CU Anschutz – Breckenridge Parking Lot Improvements

Project Number: 22-116457

Thursday, June 30, 2022
ADDENDUM 3

DESIGNED BY: RLH
DRAWN BY: SSM
CHECKED BY: MHV
MIRO JOB NO. 22017
DRAWING NUMBER: **C-101**
CU PROJECT NO. 22-116457

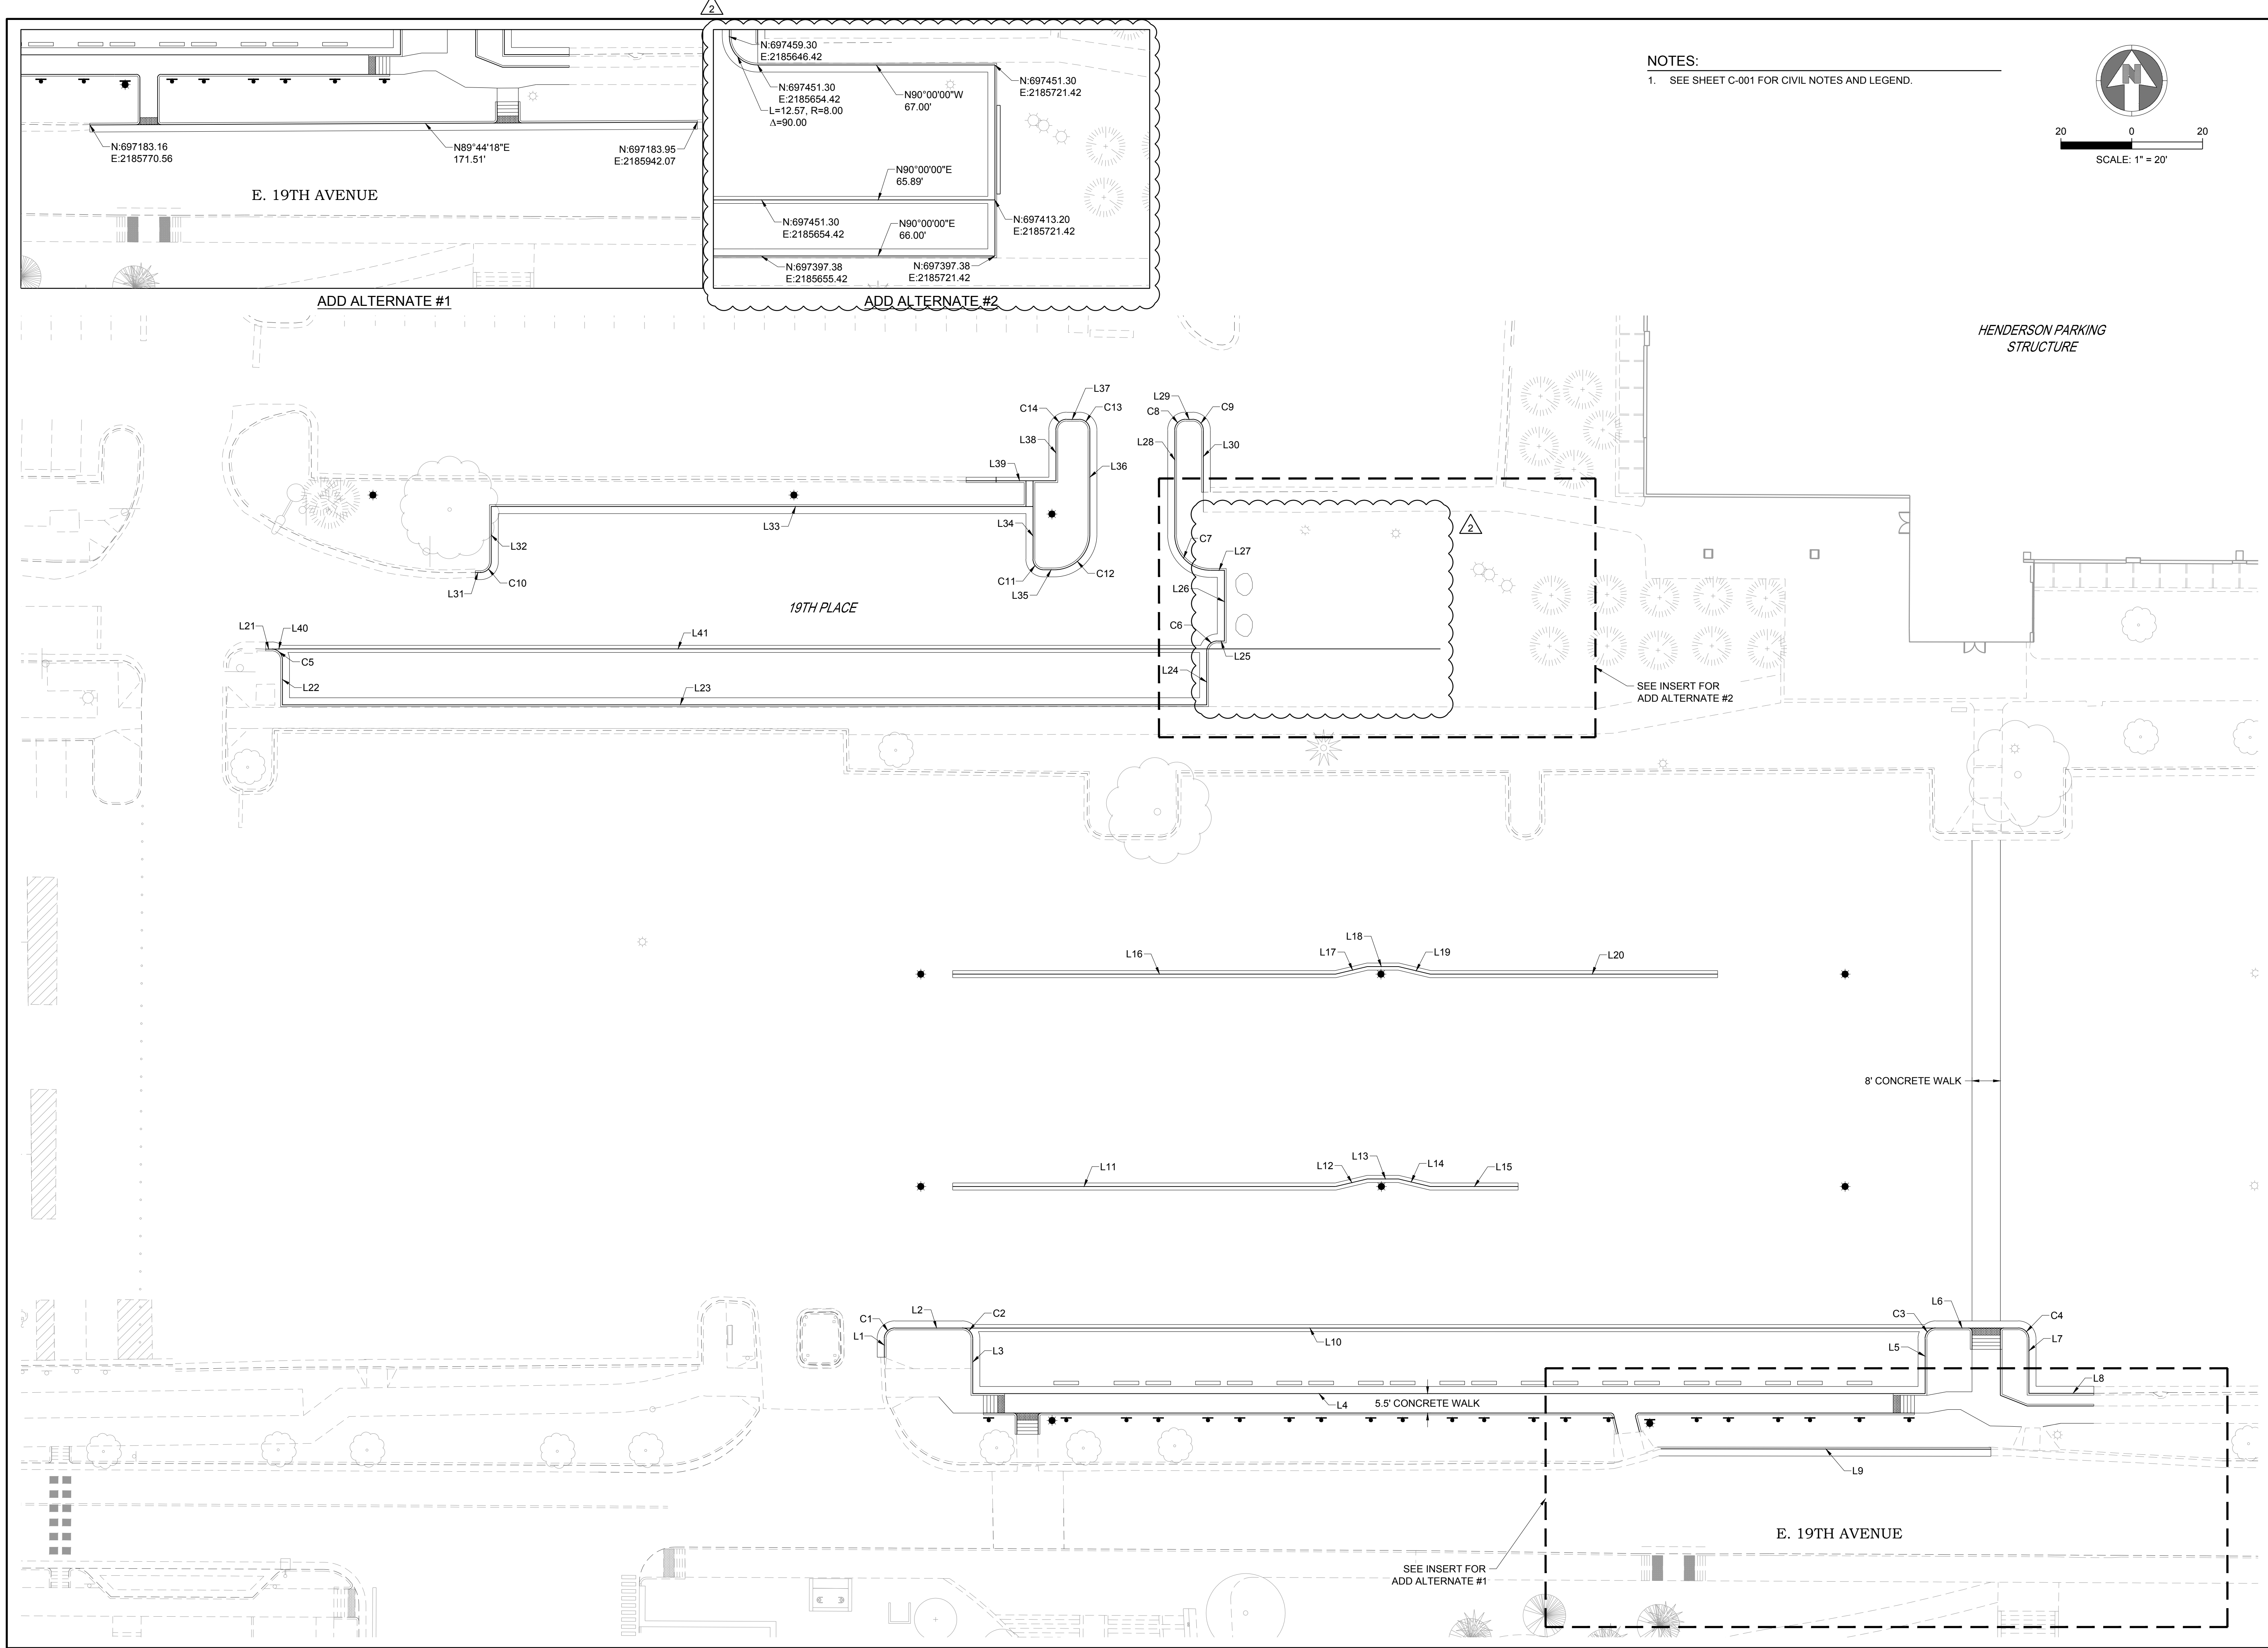
1. The following sheets have been revised to reflect an enlarged parking/snow storage area as a part of Add-Alternate 2:
 - a. C-101
 - b. C-121
 - c. C-211
 - d. C-411
 - e. C-421
 - f. C-452
 - g. C-511
 - h. ED-102
2. The following sheets have been revised to reflect comments from Pete Bloomquist, more specifically:
 - a. E-001: Removed house side shield from Luminaire Schedule and updated voltage to be Universal.
 - b. E-102: Circuit information added, revised keynotes
 - c. E-103: Circuit information added, revised keynotes
